Subject: UniStar Nuclear Energy, NRC Docket No. 52-016
Response to Request for Additional Information for the
Calvert Cliffs Nuclear Power Plant, Unit 3,
RAI 253, Seismic System Analysis

**Response to NRC Request for Additional Information
RAI No. 253, Question 03.07.02-45, Seismic System Analysis
Calvert Cliffs Nuclear Power Plant, Unit 3**

Question 03.07.02-45

**Changes to CCNPP Unit 3 COLA Associated with Response to RAI No. 253,
Question 03.07.02-45**

Figure 9.5-2— {CCNPP Unit 3 Fire Water Distribution System – Intake Structure Loop}

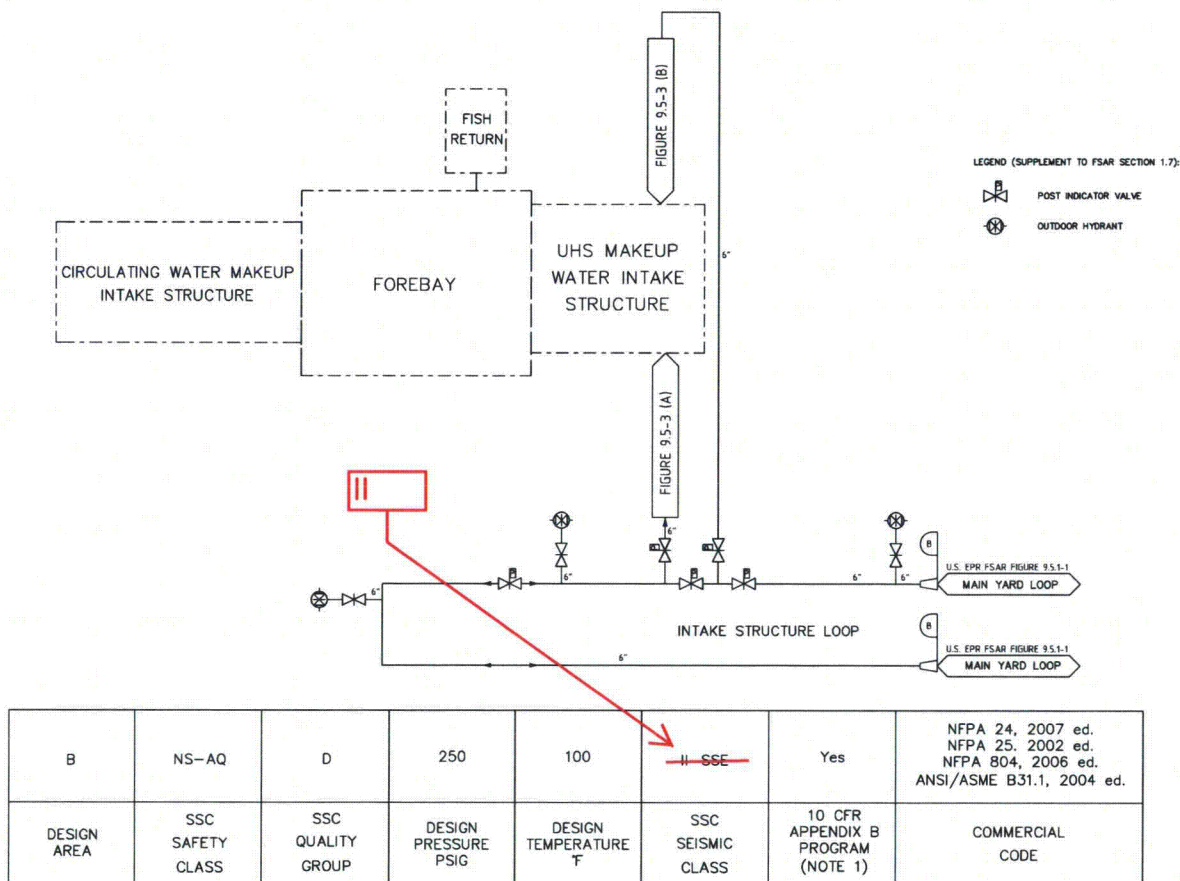
In the background portion of its response, the applicant stated that certain SSCs within the fire protection/suppression systems (including the Fire Water Storage Tanks and Fire Protection Building) do not fall into the category of SSCs that have the potential to interact with their proximate Seismic Category I SSCs, and thus these SSCs comply with SRP 3.7.2 Acceptance Criteria 8A. Criterion 8A states that "The collapse of the non-Category I structure will not cause the non-Category I structure to strike a Category I structure." However, both the Fire Water Storage Tanks and Fire Protection Building are designated as Seismic Category II-SSE (SC II-SSE) and are designed to remain elastic under SSE excitation. Therefore they are designed not to collapse and as such meet Acceptance Criterion 8C of SRP 3.7.2. The applicant is requested to clarify its response in this regard.

In the first paragraph under the second bullet of the **Response** section, the applicant states that the methods of analysis and acceptance criteria for the above ground portions of the fire protection system that are SC II-SSE are provided in U.S. EPR FSAR Section 3.9.2.2.2 (which references the AREVA Piping Topical Report) and in U.S. EPR FSAR Section 3.12. For buried segments the applicant states these requirements are provided in U.S. EPR FSAR Section 3.12.3.8 (which also references the AREVA Piping Topical Report). The AREVA topical report presents the U.S. EPR Design Certification code requirements, acceptance criteria, analysis methods and modeling techniques for ASME Class 1, 2 and 3 piping and pipe supports while Section 3.12 addresses ASME Code Class 1, 2, and 3 piping systems, piping components, and their associated supports. In neither case are the requirements or acceptance criteria for fire protection piping identified. In Table 3.2-1 for Fire Suppression Systems of the UHS MWIS, UHS EB, and Fire Protection Building and for standpipes and hose stations of the UHS MWIS and UHS EB, under the "Comments/Commercial Code" column, the ANSI/ASME B31.1 piping code is listed as being applicable. The applicant is requested to provide additional information which specifically describes the methods of analysis (seismic models, seismic input, damping values, etc.), design allowable stresses, and the piping design codes that will be used for SC II and SC II-SSE Fire Protection Systems and include this information in the FSAR.

UniStar Nuclear Energy is removing the Category II-SSE classification of the Fire Protection System (FPS) from the Calvert Cliffs Nuclear Power Plant (CCNPP) Unit 3 Combined License Application (COLA). As specified in Section 4.3.1.4 of the U.S. EPR FSAR, some nonsafety-related systems and components do not fall within the criteria for classification as Seismic Category I or II, but may still be subject to seismic design criteria that are incorporated in, or invoked by, an applicable commercial or industry code. These structures, systems, and components (SSCs) are classified as conventional seismic (CS). The FPS will be a seismically qualified system consistent with the seismic requirements of the U.S. EPR FSAR Revision 3 Sections 3.2, 3.7.2.8, and 9.5. As specified in Section 3.7.2.8 of the U.S. EPR FSAR, the Fire Protection Building (FPB) and Fire Water Storage Tanks (FWSTs) are CS structures. As specified in Section 9.5, the Fire Water Distribution System (Piping) is classified as: (a) Category II (Cat II) for piping within Category I (Cat I) facilities; (b) Cat I for piping within penetration of containment; and (c) Non-Seismically Classified (NSC) elsewhere. The SSCs categorized as CS comply with Standard Review Plan (SRP) 3.7.2 Acceptance Criteria 8A which states that "The collapse of the non-Category I structure will not cause the non-Category I structure to strike a Category I structure."

Figure 9.5-2 illustrates the site-specific fire main yard loop supplying the Intake Structure area. The ~~Seismic Category II SSE~~ loop supplies fire water to the above ground manual and automatic suppression systems identified in Figure 9.5-3. This figure illustrates the ~~Seismic Category II SSE~~ standpipe and hose stations and the Seismic Category II sprinkler systems specified for the UHS Makeup Water Intake Structure.}
